ADDENDUM NO. 4

ROSAMOND COMMUNITY SERVICES DISTRICT

ADMIN BUILDING STANDBY GENERATOR REPLACEMENT

Project No. 12609, 22609

4 RENOVATION PLAN

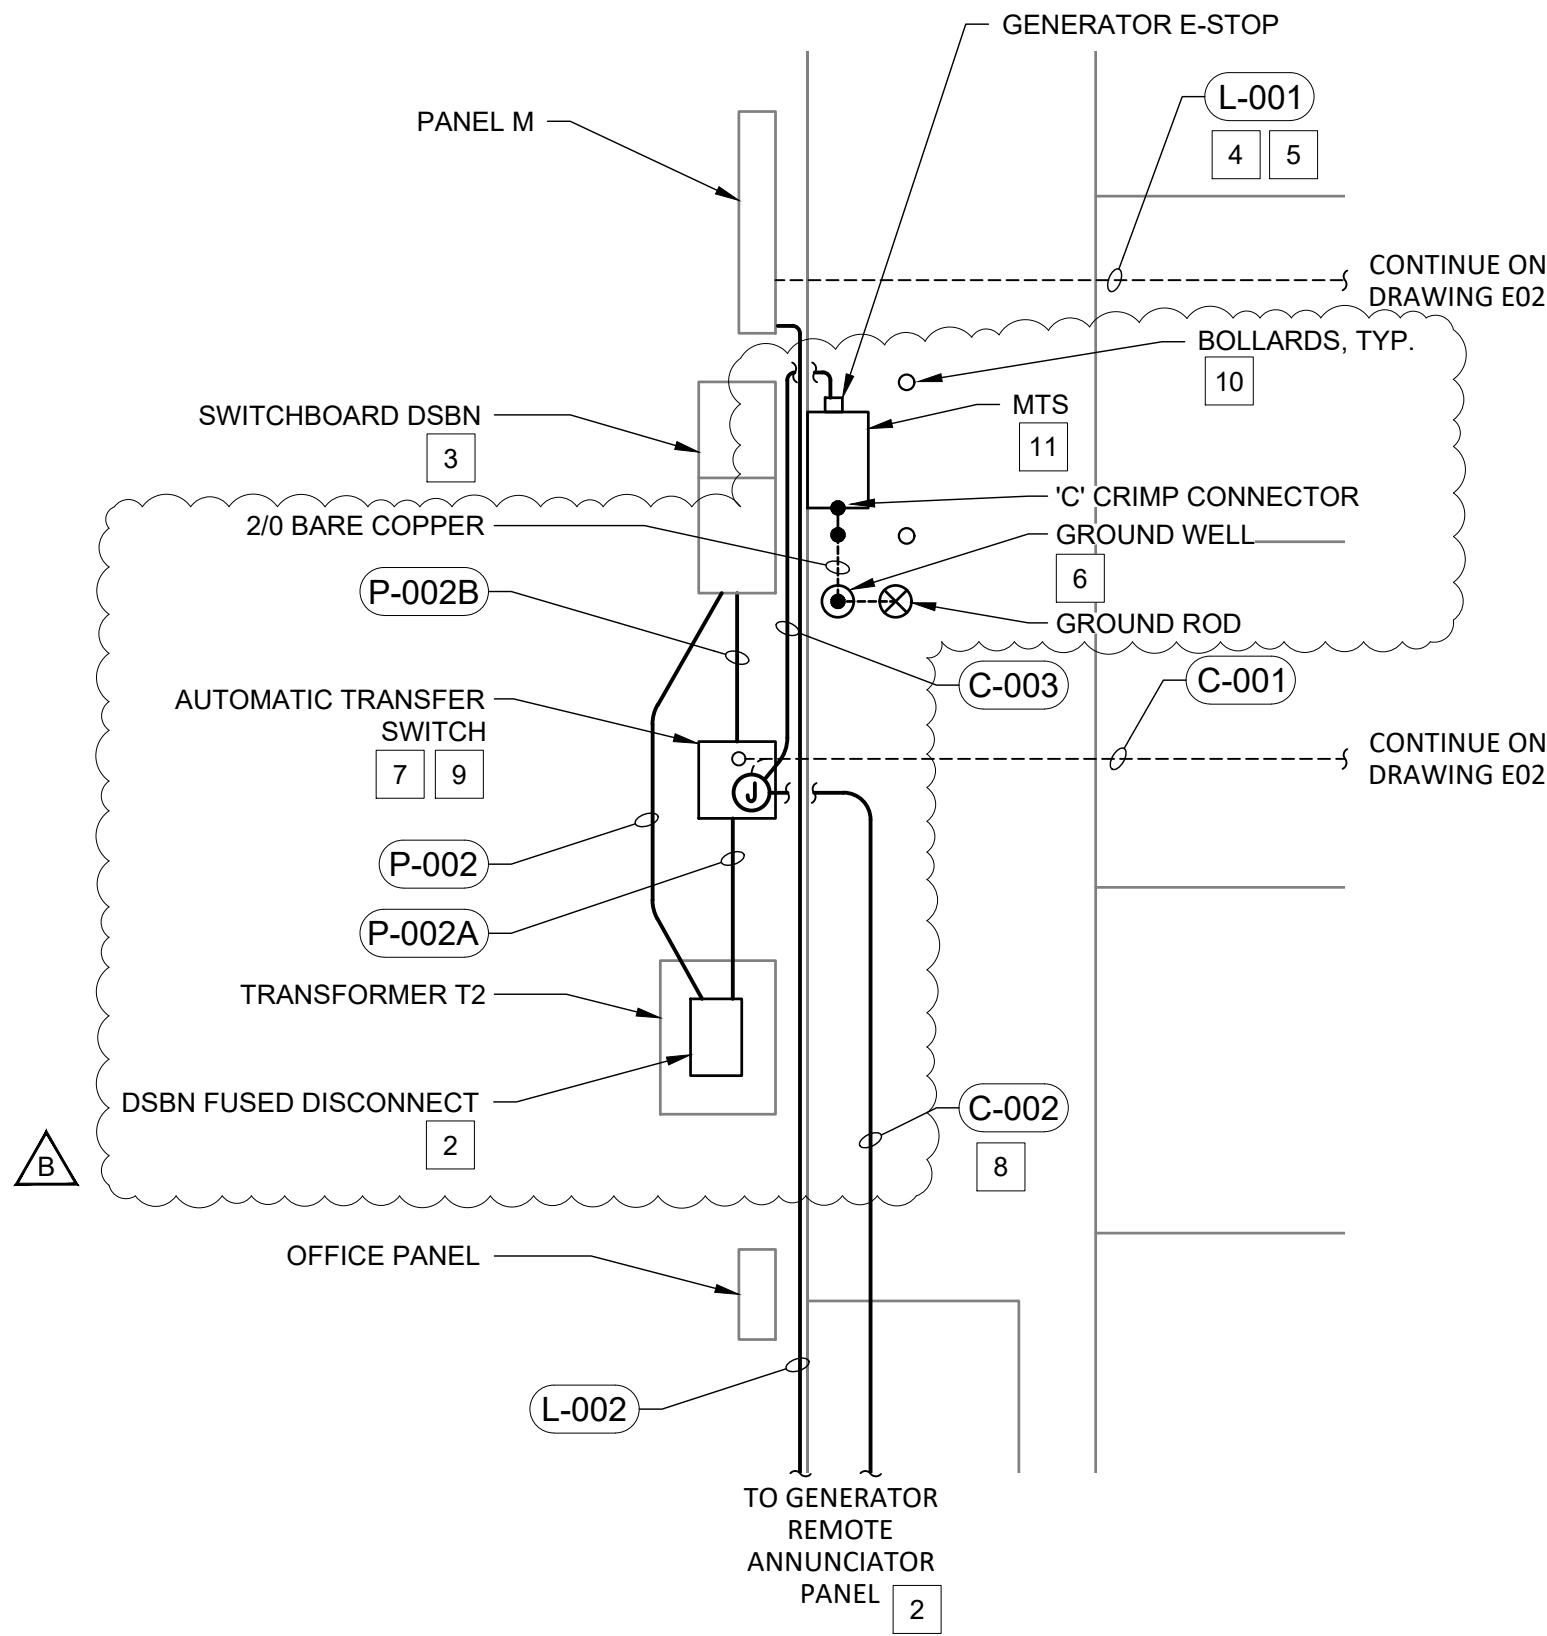
5. *How to support or remount the utility service breaker. Currently it is sitting on the ATS.*

12. *Clarify on E03-Detail 4, if C-002 and L-002 are new or existing.*

13. *Where is the manual transfer switch (MTS) for future rental generator hook-up to be located?*

Response: Contractor shall relocate utility disconnect switch over transformer. Contractor shall build a support frame using galvanized steel Unistrut placed around transformer. Anchor support frame to floor and mount utility disconnect switch to the Unistrut frame. See revised E-03, Detail 4 and Renovation Notes.

Response: See revised drawing E-03, Detail 4. MTS will be located outside electrical building adjacent to PV Disconnect switch. Install safety bollards as shown.

CONTRACTOR SHALL RELOCATE THE UTILITY DISCONNECT SWITCH ABOVE THE TRANSFORMER. CONTRACTOR SHALL PROVIDE AND INSTALL A SUPPORT FRAME CONSTRUCTED OF GALVANIZED STEEL UNISTRUT AROUND THE TRANSFORMER. ANCHOR THE SUPPORT FRAME SECURELY TO THE FLOOR AND MOUNT THE UTILITY DISCONNECT SWITCH TO THE UNISTRUT SUPPORT FRAME.
- 3

SINGLE LINE DIAGRAM 7

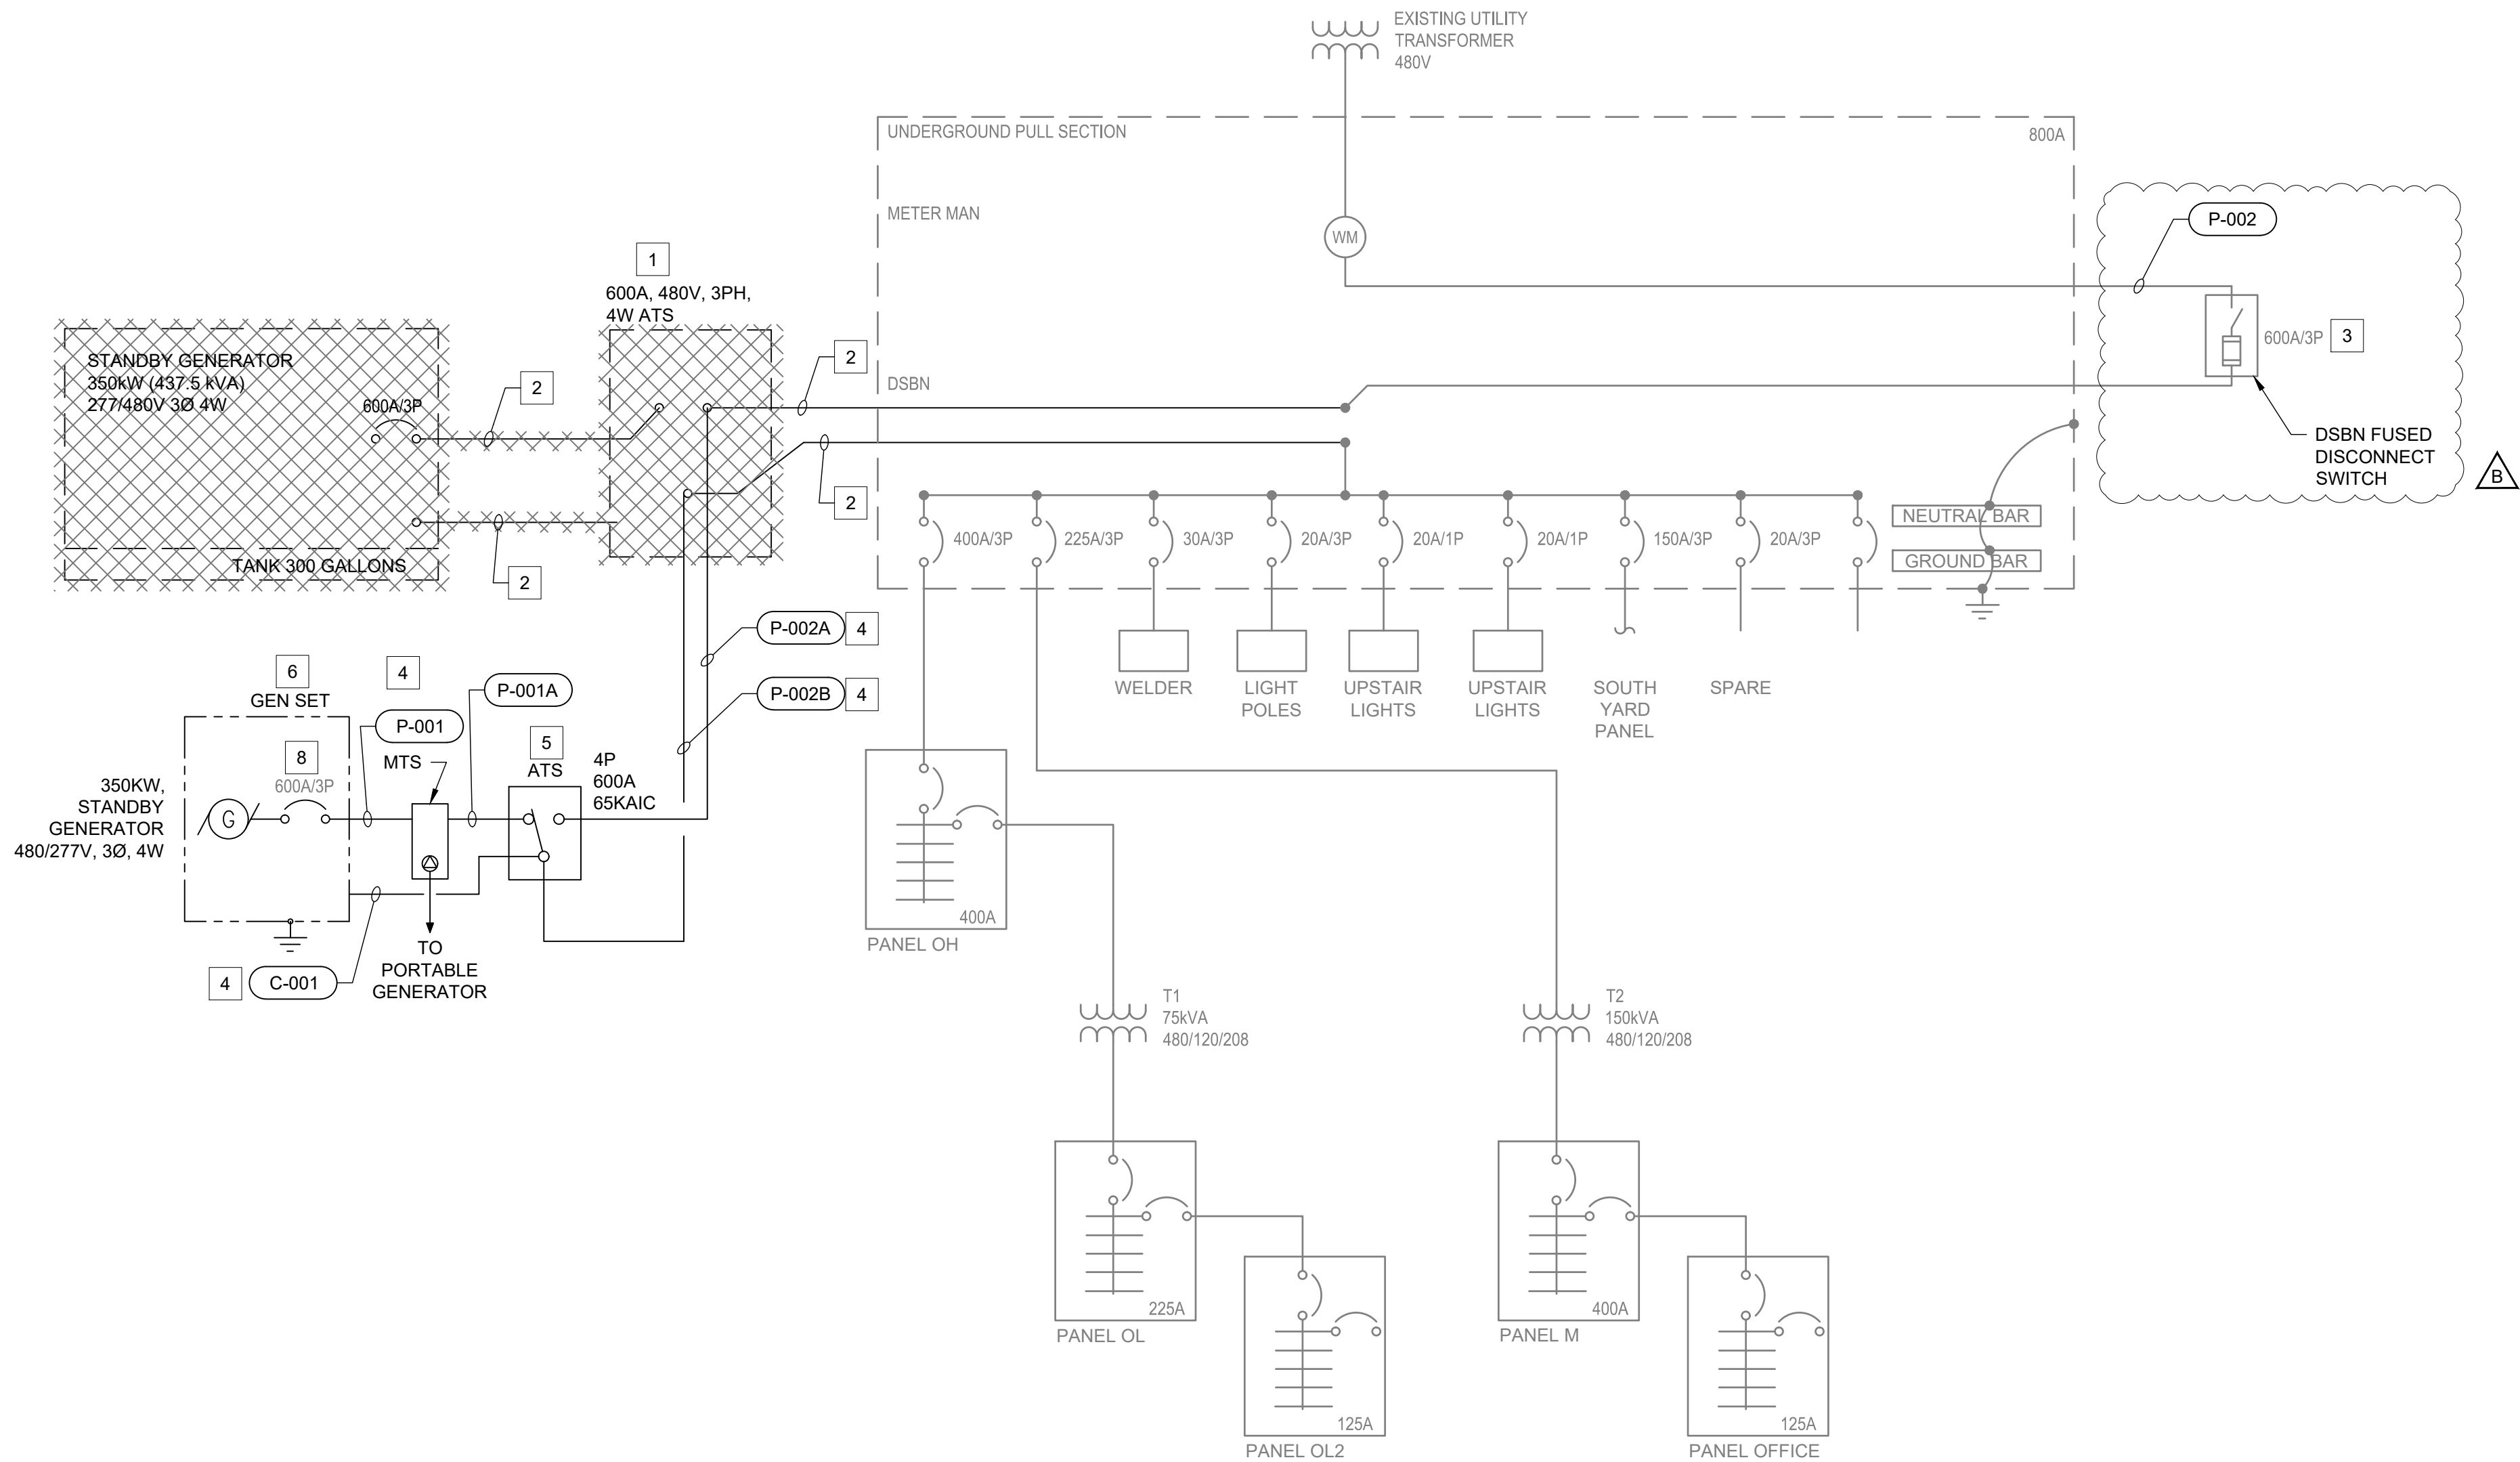
8. *Is the disconnect switch on the exterior of the electrical room labeled 'Warning - A Generation Photovoltaic Source is Connected to the Supply Utility Side of the Service Disconnection' connected upstream or downstream of main utility disconnect?*

Response: Contractor shall conduct circuit tracing from the utility source to the ATS, all disconnects, and equipment downstream of main utility disconnect. See Note 7 on E-04. Submit red-lines of the 1-line diagram for District review prior to demolition or installation activities.

DETAIL - GENERATOR PAD

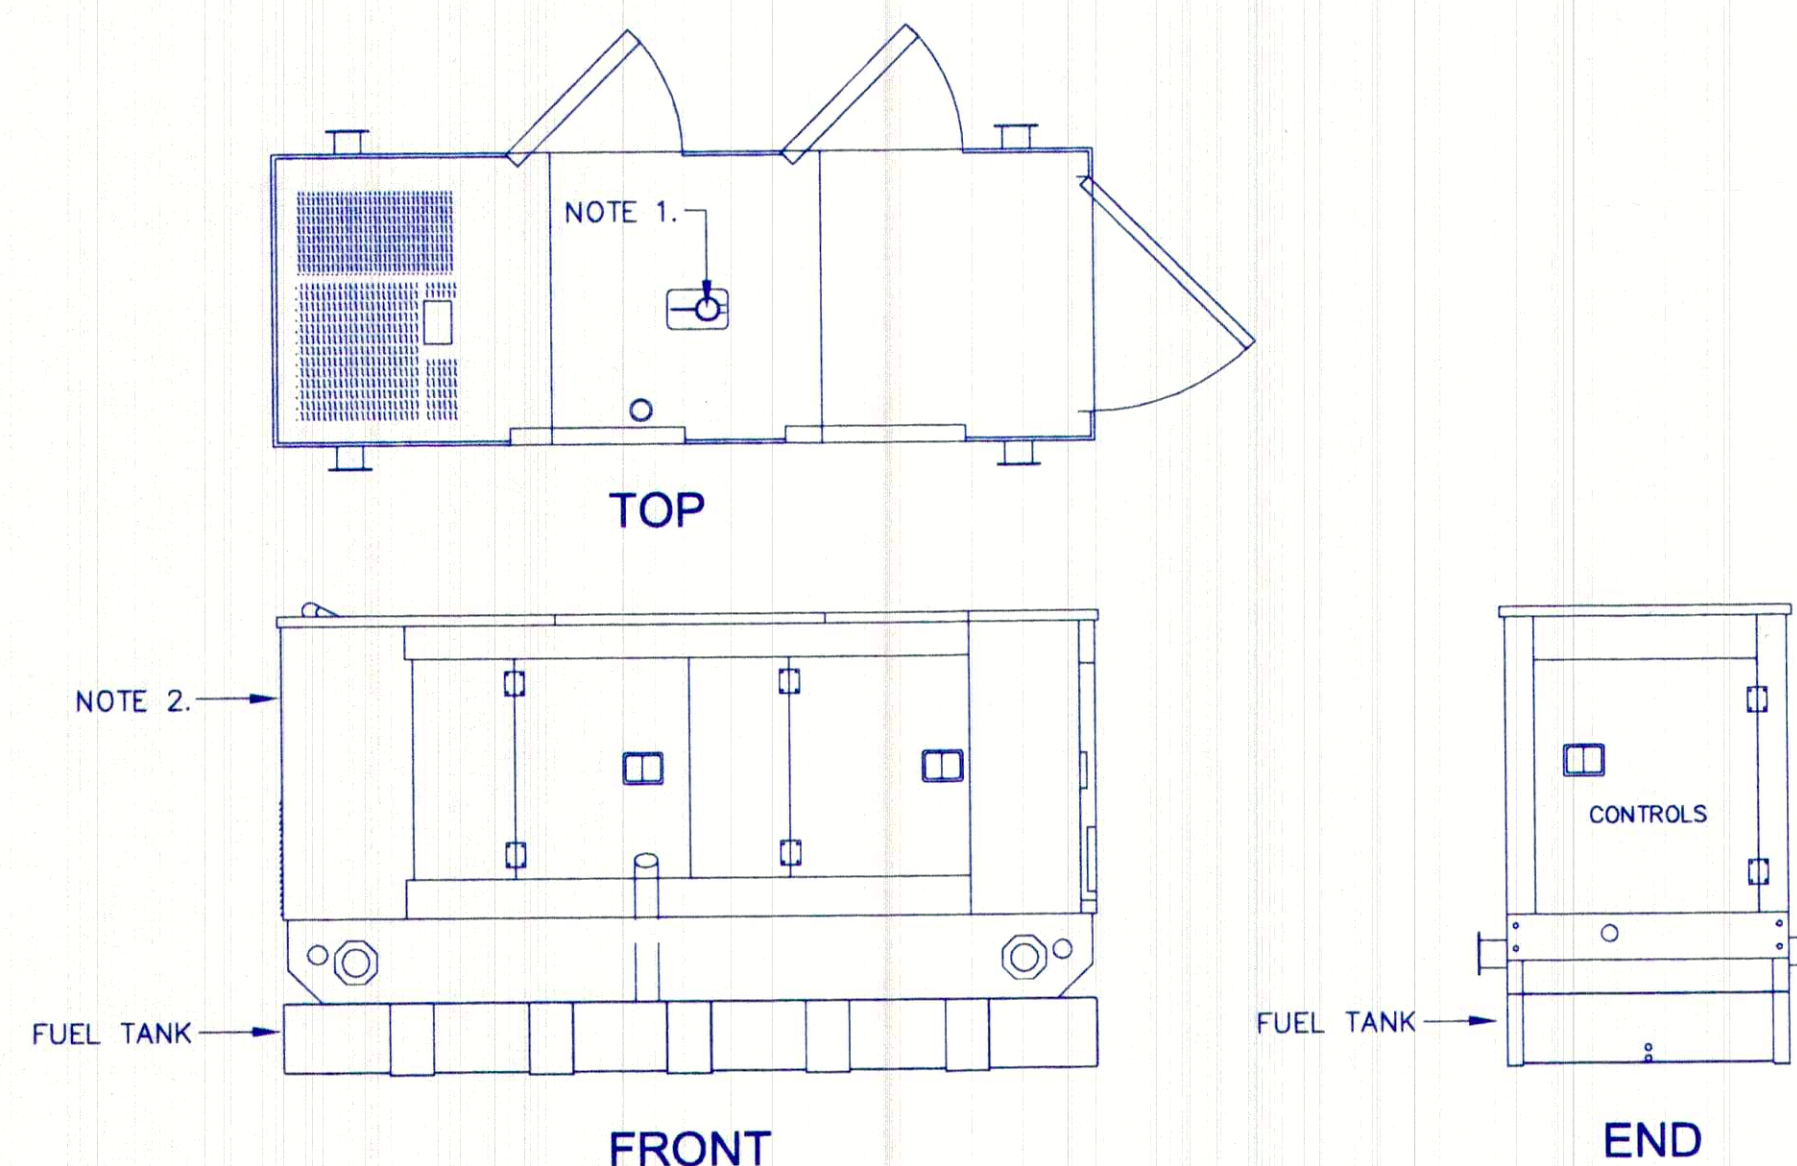
14. *What are the seismic anchor requirements for the generator?*

Response: Contractor shall submit anchorage plan and calculations 30 days prior to equipment or material ordering for attaching the Generator Assembly to the reinforced concrete Generator Pad. See attached for detail of existing generator pad.

1. Anchorage design shall be in accordance with the 2025 CBC, utilizing site-specific seismic and wind criteria.
2. The anchorage plan and calculations shall be prepared by a qualified engineer registered in the State of California. Anchorage shall include spring-type vibration and seismic isolators (CalDyn Type RJJEQ or similar). For outdoor locations, anchors shall be epoxy type.
3. The conduit stub-up area shall be completely sealed at the interface to the concrete pad to prevent rodent intrusion into the generator enclosure.
